From: [Ford, William](#)
To: [Martinez, Nancy](#)
Subject: RE: TURKEY POINT: Draft Collective Response to Flooding Questions
Date: Thursday, July 18, 2019 5:52:11 PM

Subject: TURKEY POINT: Draft Collective Response to Flooding Questions

Response to FKAA Groundwater Model Review

RE: Florida Power & Light Company Phase I Remediation Action Plan Submittal

Figure 2. Simulated wetland (Model Layer 1) drawdown after 9 years of Alternative 3D extraction well operation using the original (pre-revision) models and revised boundary condition models

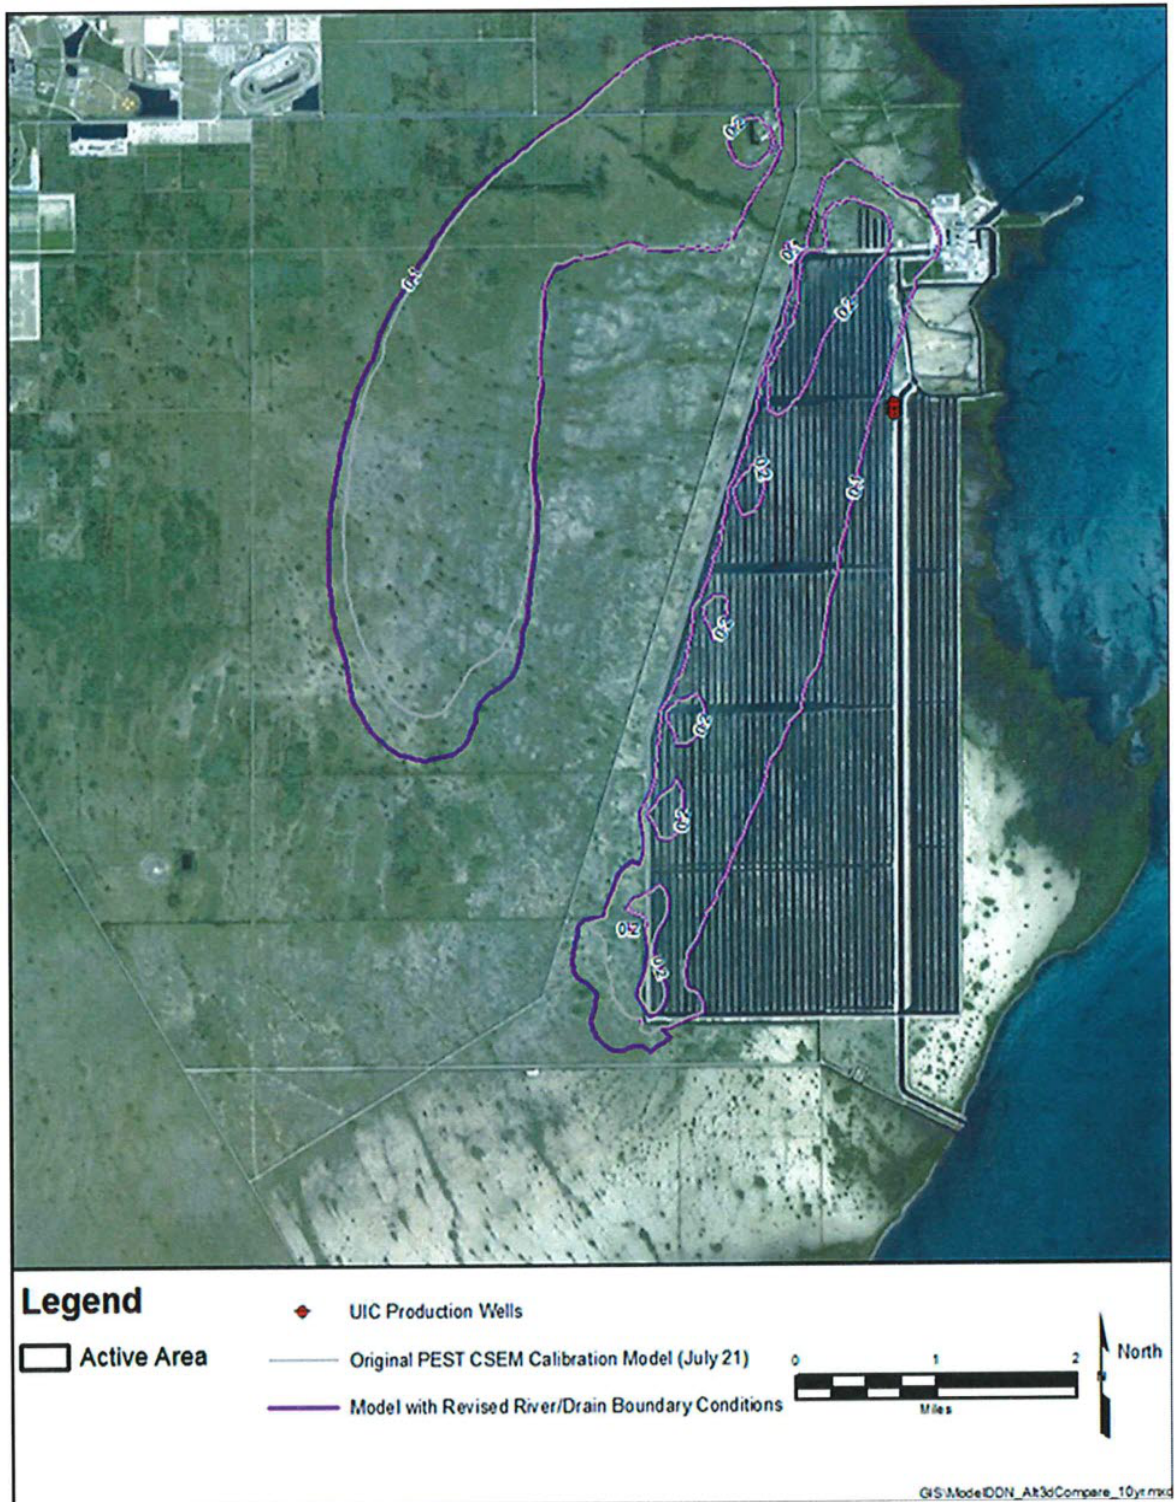
Simulation of Recovery Well Systems (RWS) Alternative 3D with the revised boundary condition model yielded similar, yet slightly different results in terms wetland drawdown. Inspection of Figure 2 reveals that the revised model simulates a slightly greater extent of drawdown in wetlands. The slight increase in the extent of wetland impacts simulated by the revised model is consistent with the conversion of L-31E (south of S-20) from a RIV boundary condition (potential source of water to the model) to a DRN boundary condition (not a source of water to the model).

FPL Response: Drawdowns associated with recovery well system Alternative 3D in layer one (wetlands) of the PEST calibrated model with the SFWMD recommended boundary changes are shown on Figure 2 of the TetraTech technical memorandum entitled *"Addendum to Regional Biscayne Aquifer Groundwater Model Report Incorporating Comments from SFWMD"* (Attachment 2). Drawdowns beneath wetlands are less than 0.3 feet. The Model Lands wetlands within the drawdown influence of Alt 3D are predominantly seasonally inundated emergent marshes which are categorized as Category 2 wetlands in the *"Applicants Handbook for Water Use Permit Applications (09/07/2015)"* by the SFWMD. Numeric criteria for Category 2 wetlands in SFWMD water use permit rules state that drawdowns less than one foot beneath wetlands are not considered harmful. Drawdowns resulting from withdrawals associated with Alt 3D are much less than one foot and are therefore considered not to create potential adverse environmental impacts to surrounding wetlands.

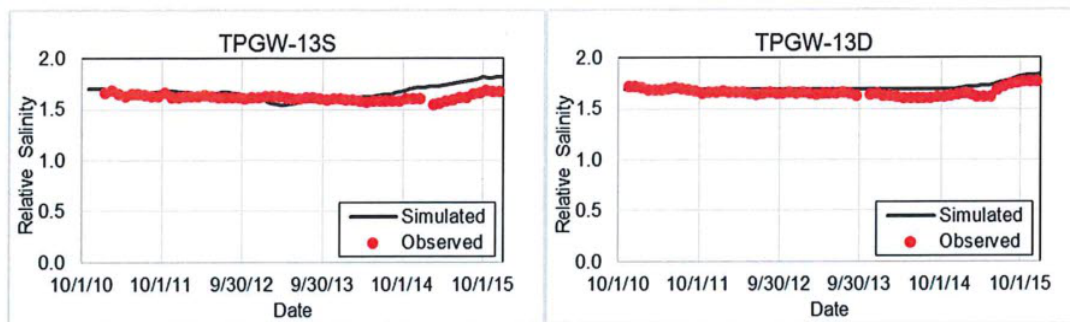
FKAA Comment: The varying rates of net recharge part way through the calibration period are not clearly tied to calibration efforts. Some explanation for these changes is required.

FPL Response: Starting in 1996, NEXRAD-based estimates of precipitation and potential evapotranspiration provided a relatively detailed assessment of precipitation, and were employed to define seasonal recharge for the latter part of the seasonal model (1996 to 2010). Prior to 1996 in the seasonal model, wet and dry seasonal recharge was based on average seasonal precipitation and evapotranspiration, as calculated from available NEXRAD data. A more detailed discussion of precipitation data and the associated estimates of recharge is provided in the modeling documentation (Tetra Tech, June, 2016).

Figure 1. Net recharge (inches/season) applied in the seasonal calibration model.

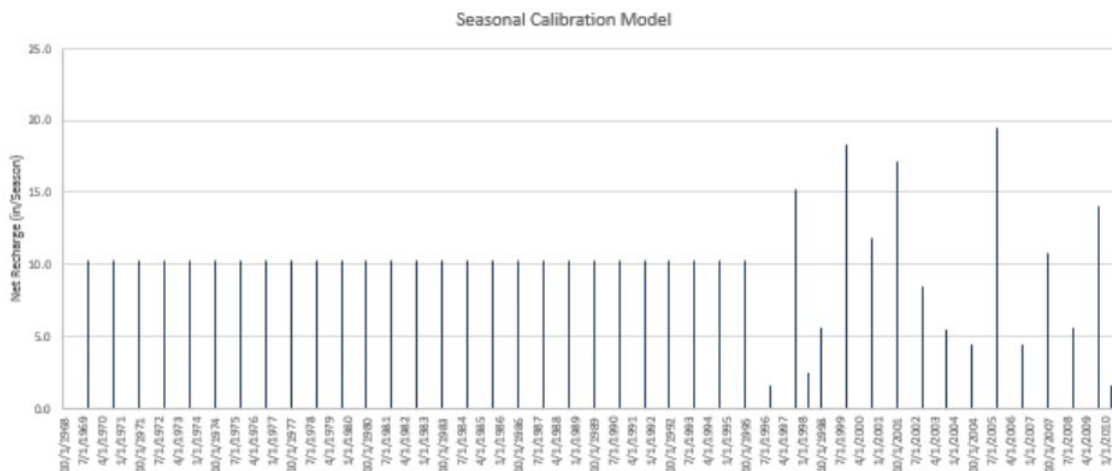
Figure 1 shows the net recharge applied in each stress period or season in the model at a selected location (R255 C21). It indicates that the most recharge occurs during the wet seasons as expected. A recharge of 10 inches per year in the wet season is applied uniformly from 1968 to 1995 whereas variable recharge rates are applied from 1996 through 2010 including net recharge being applied during the dry season in certain years. The technical memorandum does not indicate why the recharge rates were varied. Presumably, the change could be part of the calibration process. However, it is not clear why the recharge from 1968 to 1995 are uniform or why the change was made for years after 1995.

The net recharge in some years appears to be very high. For example, the net recharge was almost 20 inches in the wet season in 2005, which is about one third of annual precipitation. It should be noted that since the following figure only shows the recharge at one arbitrarily selected location, it might not necessarily represent the entire model area.

Figure 2. Dry cells in model Layer 1 at the end of stress period 1 in the monthly calibration model.

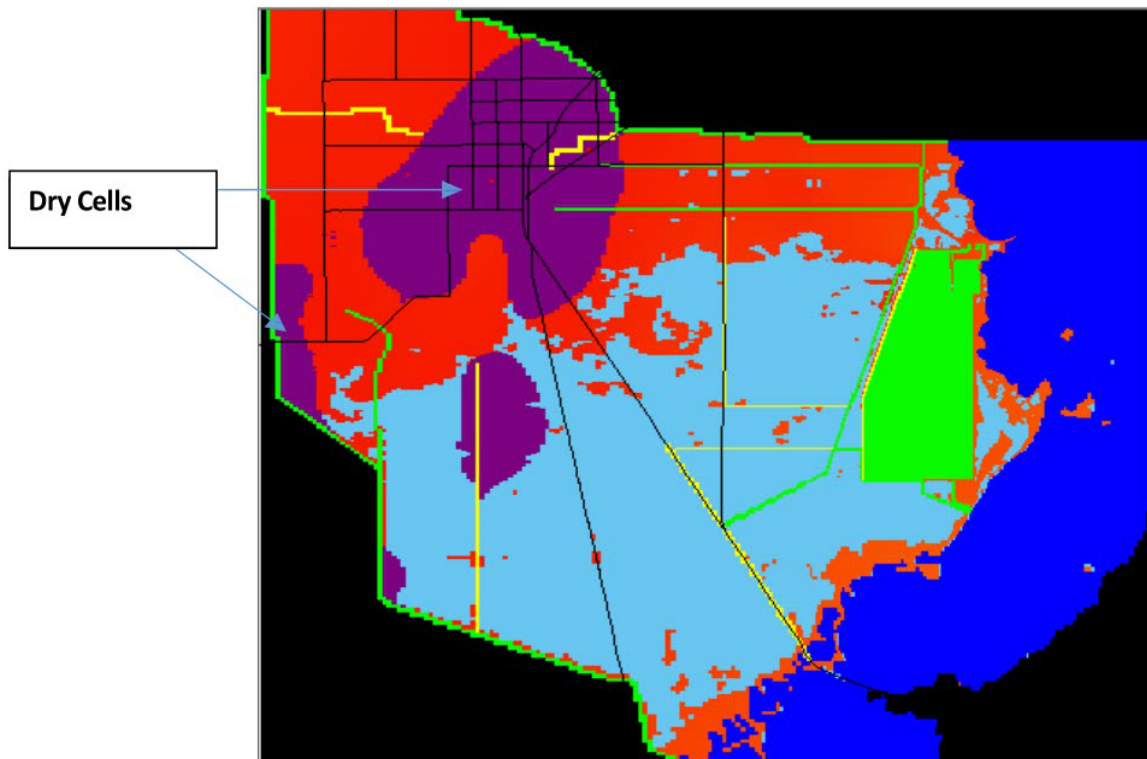
A large area of dry cells appears at the west side of the model with some dry cells appearing just after the first stress period in the monthly calibration model (Figure 2).

Figure 3. Simulated water levels (ft, NGVD) for December 2015, in Layer 8.

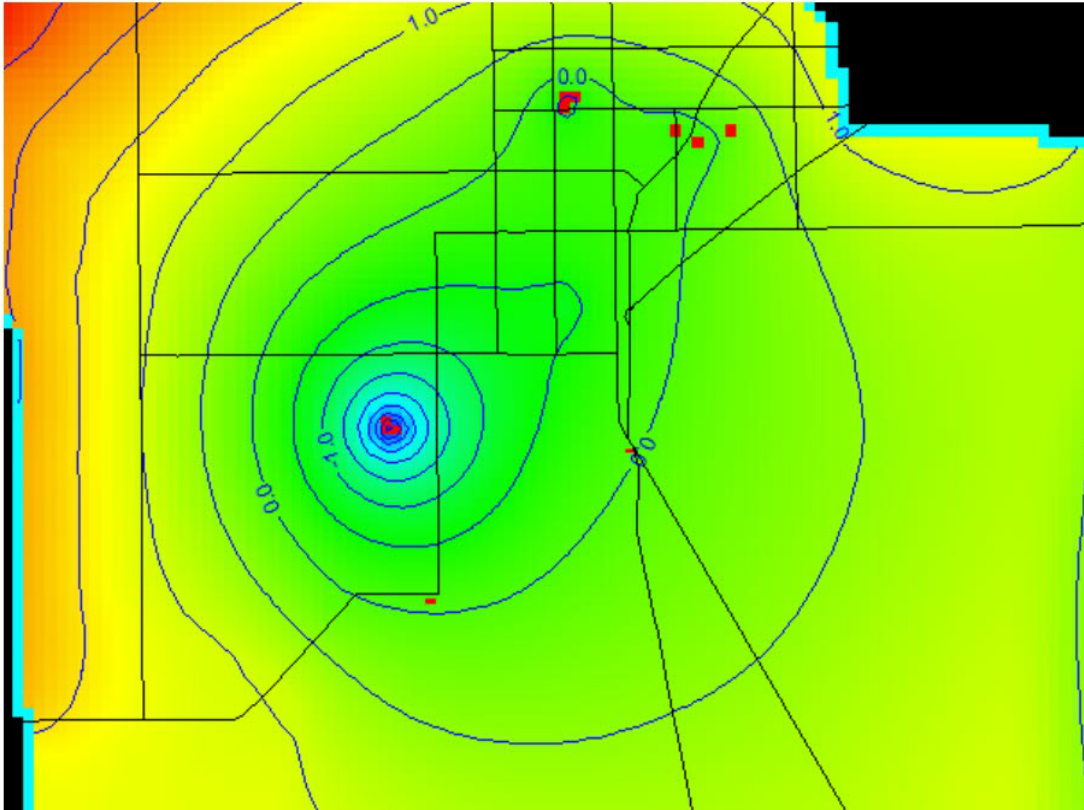
The model results also show a large area of drawdown due to withdrawals from the FKA wellfield (Figure 3). Such a large extent of cone of depression is not consistent with field measurements and likely represents an inaccurate simulation of the wellfield influence in an area of extremely high transmissivity. The effect of model boundary interference with wellfield drawdown may also be indicated.

Figure 15. Simulated salt concentration changes in model Layers 5, 7, 9, and 11 in the seasonal calibration model.

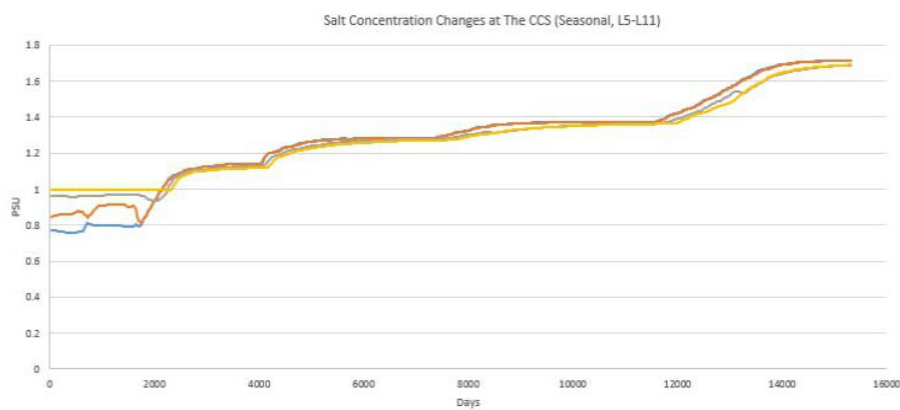
As shown on Figure 15, the maximum salinity in the CCS simulated in the seasonal model is about 1.8 PSU. It is relevant to note that salinity as high as 3.0 PSU has been reported for CCS (Chin, 2015). Higher salinity, up to about 2.7 PSU as shown in Figure 17, was applied to the CCS in the monthly model. However, due to change in canal conductance at that time, the salinity in deeper layers appears to not be impacted by the salinity in the CCS. It needs to be understood why the simulated salinity does not match the observed peak salinity values in the canal and how the low conductance in canal post 2013 is affecting the salinity in lower model layers.

Figure 16. Simulated water levels in the CCS canal and model Layer 1 in monthly calibration model.

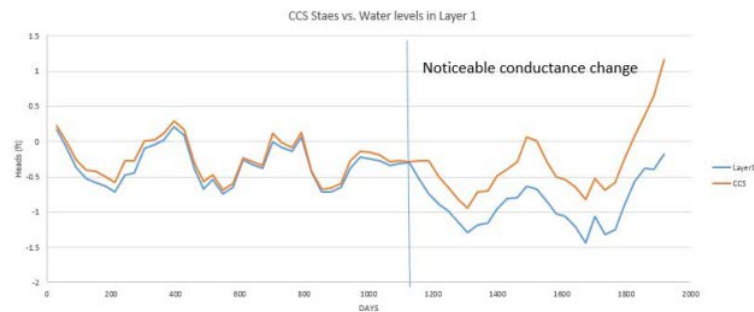
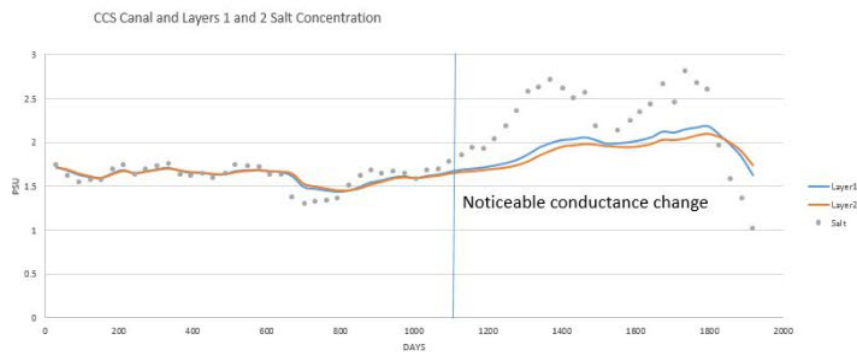
was made towards the end of the calibration period, and it seems to have occurred only at the CCS area. However, the change indicates a very different set of conditions for the remediation simulations as compared to the model calibration efforts. The impact of this change may also significantly affect the simulation results as shown in Figures 16 and 17.

Review of the figures indicates that the simulated heads and salinity start to deviate from the values specified in the CCS after the river conductance values are reduced. This impact is also observed in the model calibration time series (from the Tetra Tech PowerPoint presentation presented as Figure 18).

Figure 18. Salinity calibration results of the monthly model (Tetra Tech, 2016).

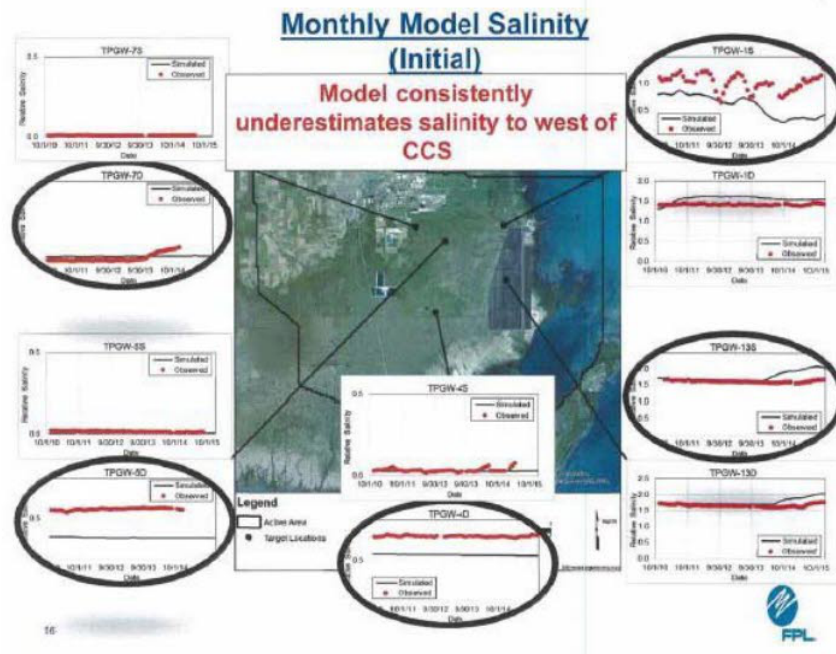
As shown above, simulated salinity values in the calibration target monitor wells, TPGW-13S and TPGW-13D, started moving away from observed values at approximately the end of 2013. Another monitoring well, TPGW-7D, located a significant distance away from the CCS, also showed a similar pattern change. The revised river conductance values for the CCS were used in all of the predictive models. This is a concern. The change of the river conductance beneath the CCS was significant and made at a very late stage of the model calibration period. The reduced river conductance may not be representative of actual field conditions and was not considered during most of the model calibration period. The validity of the prediction scenarios are therefore placed in question because of the significance of the change and the late stage of the change in the area most critical for performance evaluation of the proposed remediation measures.
